**Alternate 5 - Ballard Handrail**

**CITY OF WICHITA**  
**WICHITA CENTRAL CORRIDOR**  
**ALTERNATE 5**  
**1ST STREET**  
**GENERAL PLAN AND ELEVATION**

| KANSAS | 472-84071   | 2005 | B6.1      |              |

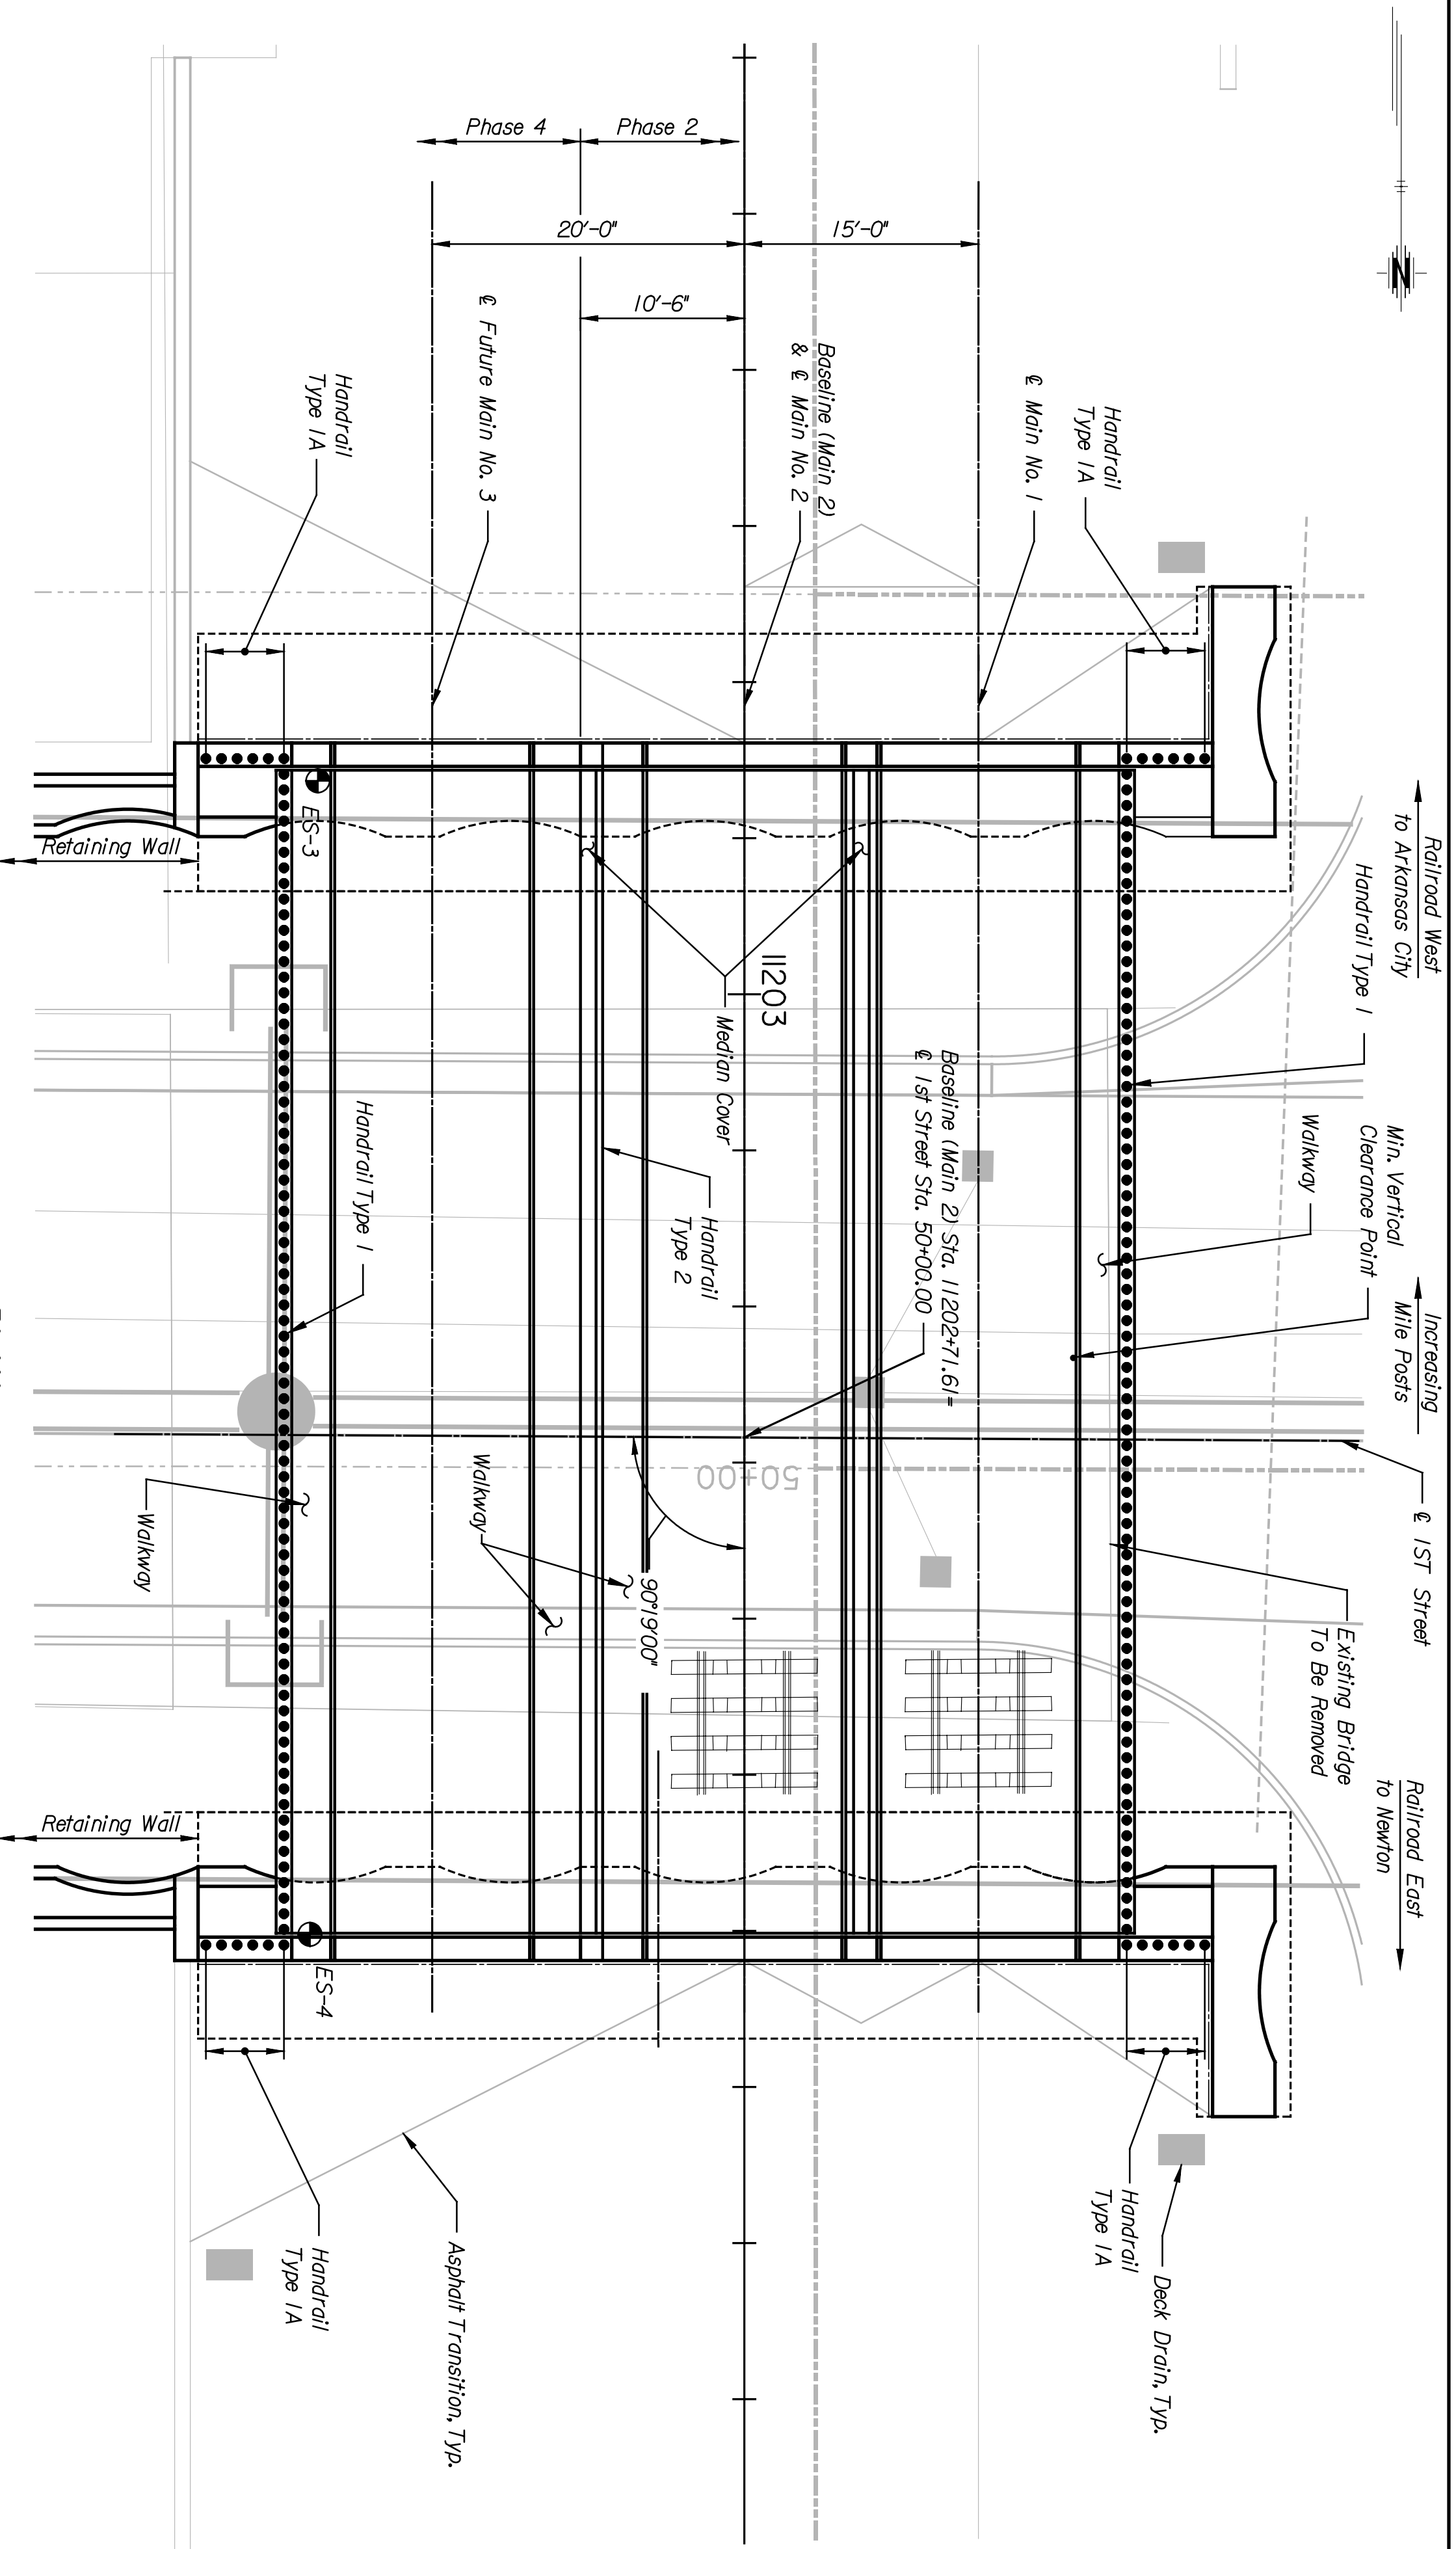
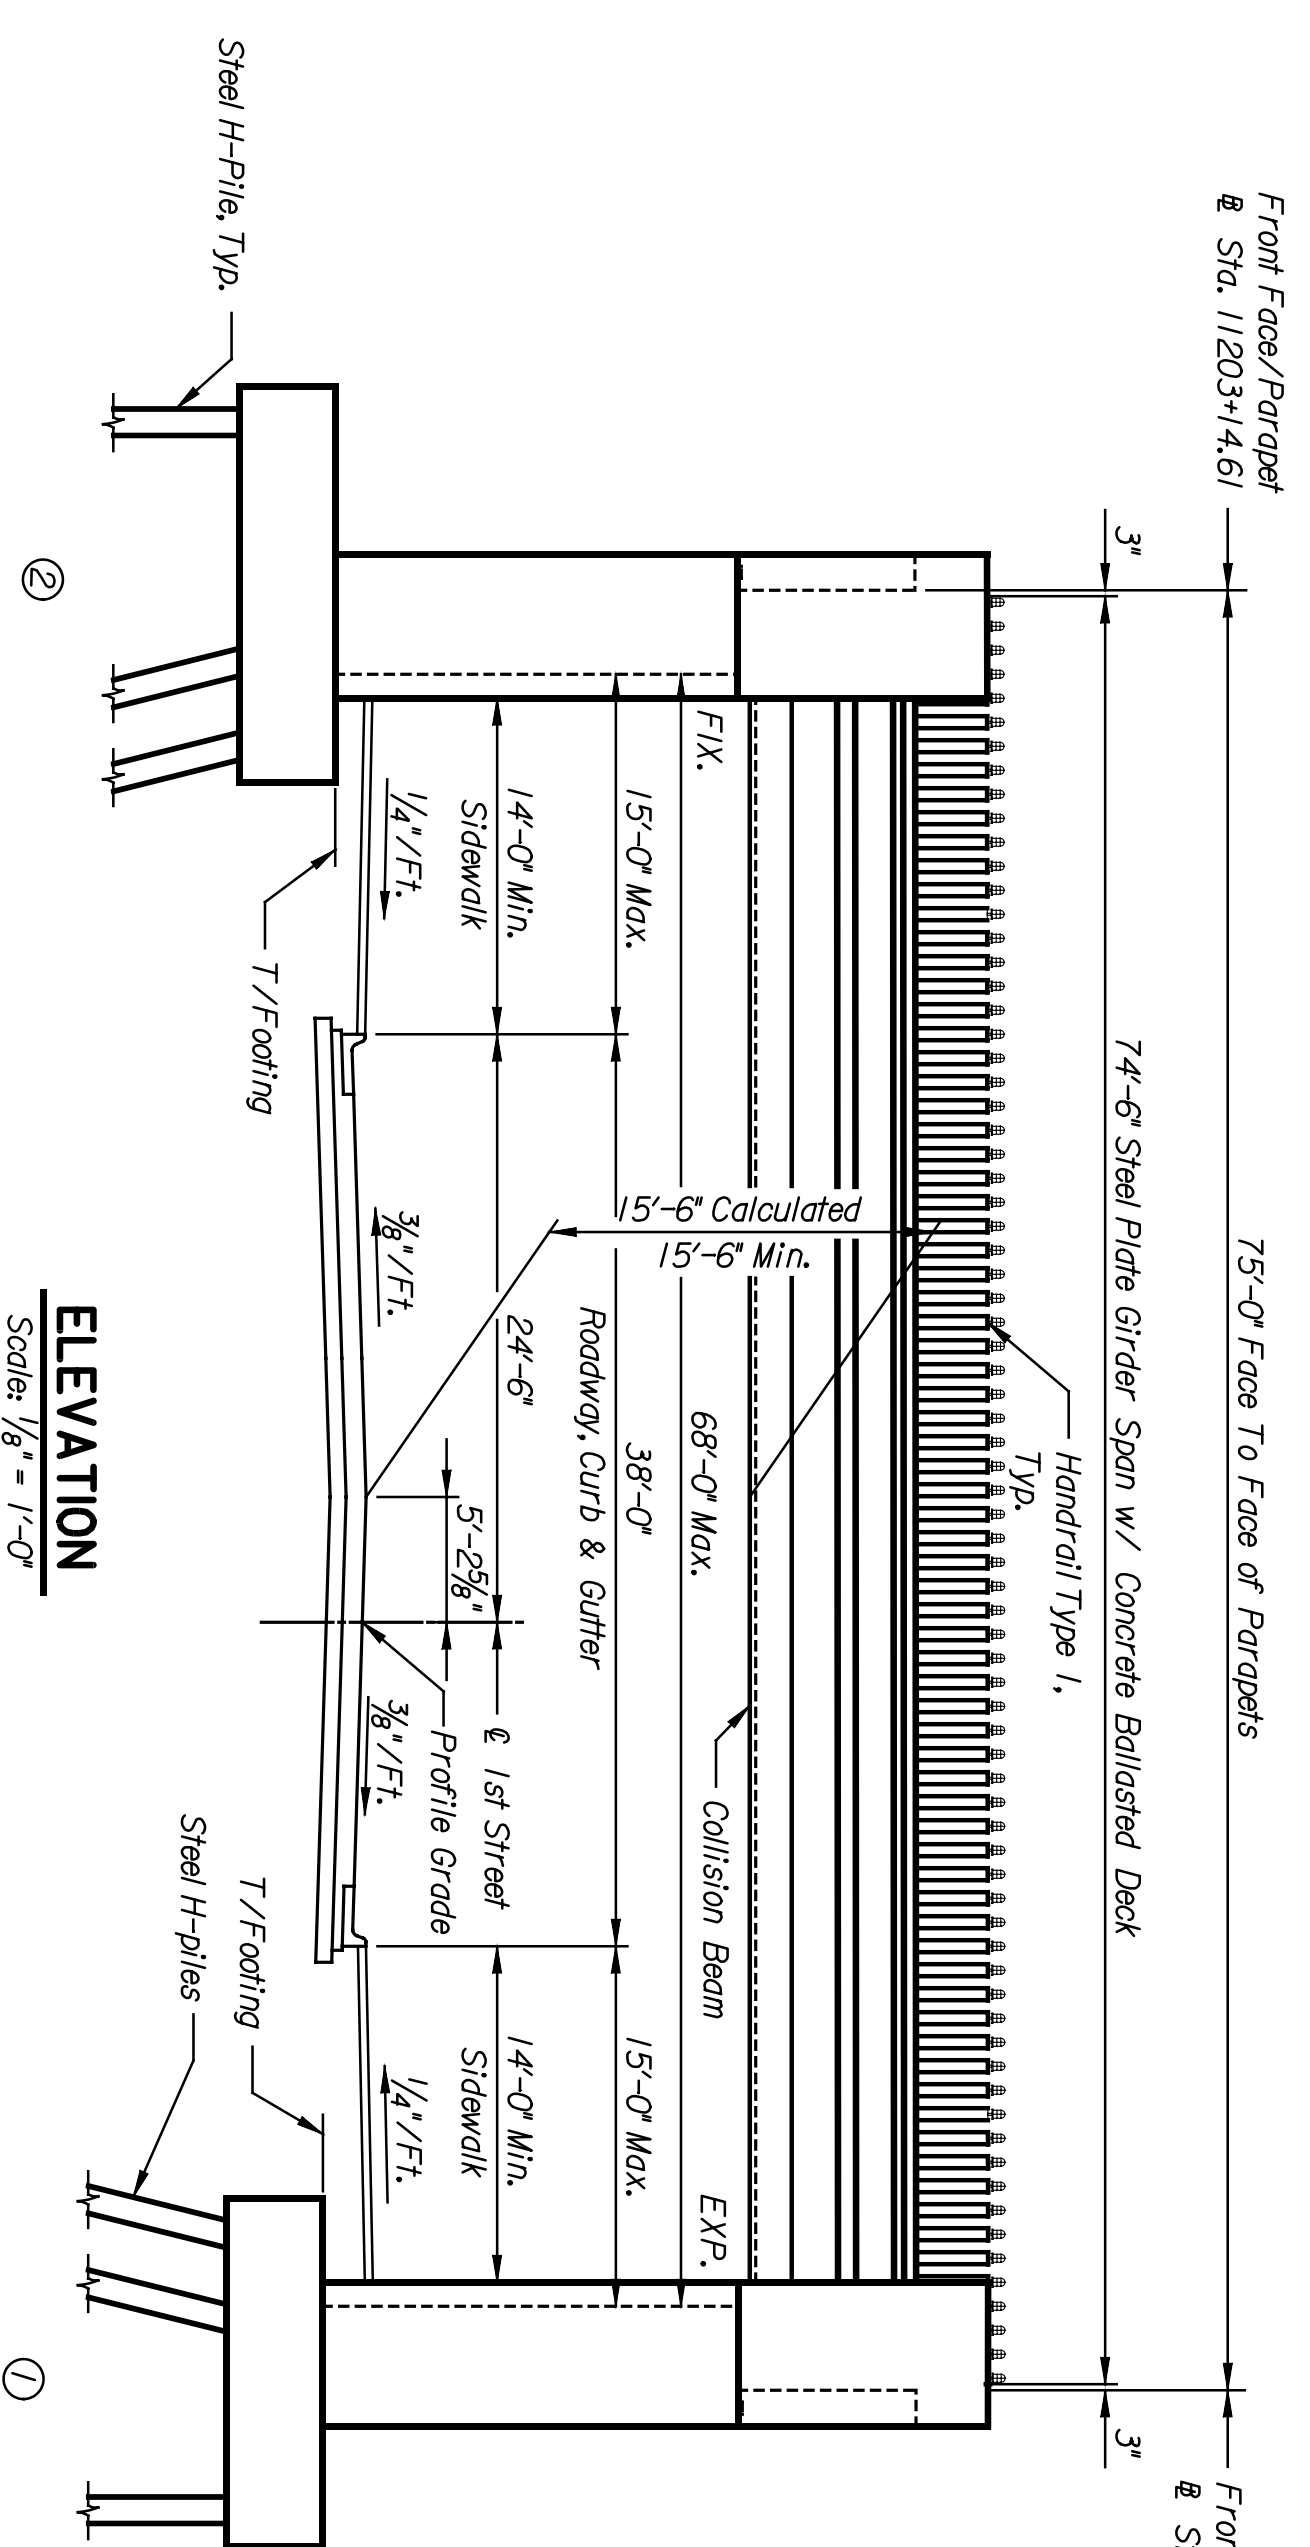
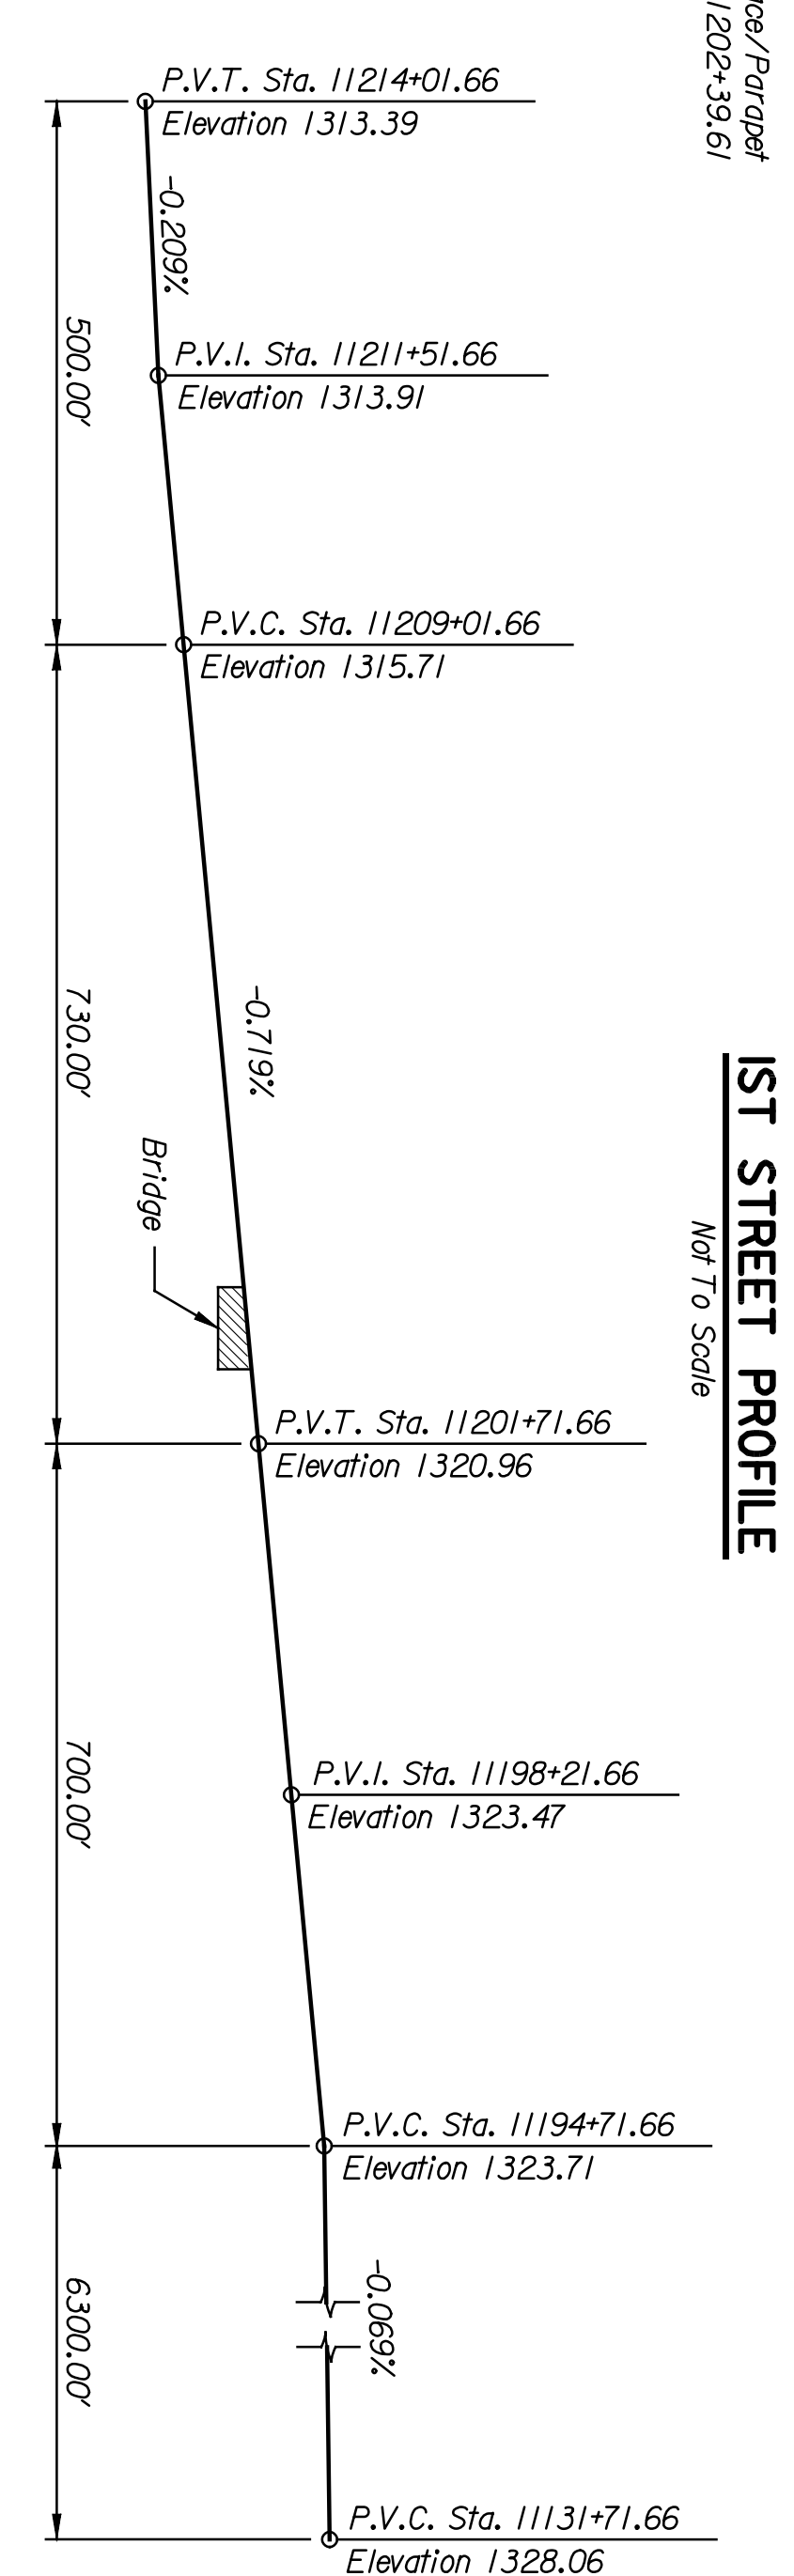
Explanation: The standard pipe handrails on the outer walkways of the bridge have been replaced with bollard lights as an aesthetic treatment. The pipe handrail between Main 2 & Main 3 remains unchanged.
